# UNITED STATES PATENT AND TRADEMARK OFFICE

10/721,857

<b>Office Action Summary</b>	<b>Application No.</b> 10/721,857	<b>Applicant(s)</b> BURBANK ET AL.	
	<b>Examiner</b> ELIZABETH HOUSTON	<b>Art Unit</b> 3731

## DETAILED ACTION

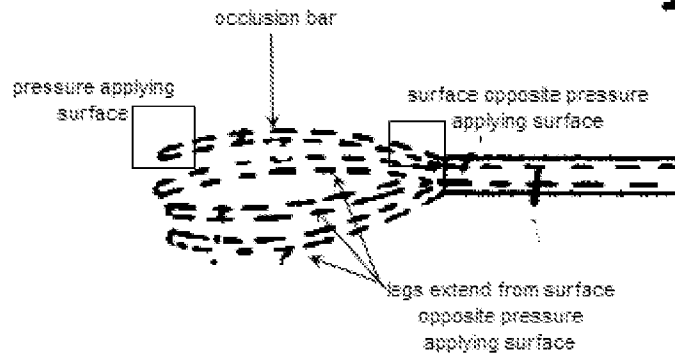
6. Hasson discloses an intravaginal device capable of occluding a female patient's uterine arteries with an unsymmetrical anatomy to treat a uterine disorder, comprising: a first occluding member having a first elongated shaft (14), a first operative proximal shaft section (88,90) configured to extend out of the patient during treatment, which has a first distal shaft section (18) with a first pressure applying occluding element (82) secured to the first distal shaft section (in that all the elements of the device are secured to each other), and a first mechanism/extending actuator (86, 92) to distally extend at least part of the first pressure applying occluding element from a first position closer to the first operative proximal shaft section to a second position further away from the first operative proximal shaft section and for moving the first pressure applying surface distally away from the distal end of the first elongated shaft (Fig. 7; C6:L6-18); wherein the first pressure applying element includes an occlusion bar with a pressure applying

surface and a pair of legs which extend from a surface opposite the pressure applying surface (see below); and a second occluding member (16) having a second elongated shaft, a second operative proximal shaft section configured to extend out of the patient during treatment and a second distal shaft section with a second pressure applying occluding element secured to the second distal shaft section; and a connection (46) between the first and second occluding members which is configured to adjust spacing between the first and second pressure applying occluding elements (C5: L13-20) to press the pressure applying occluding elements against the patient's vaginal wall to occlude underlying uterine arteries. Regarding claim 2 the second occluding member has a second mechanism to distally extend at least part of the second pressure applying occluding element from a first position closer to the second operative proximal shaft section to a second position further away from the second operative proximal shaft section (see Fig. 1 and above elements with respect to first occluding member).
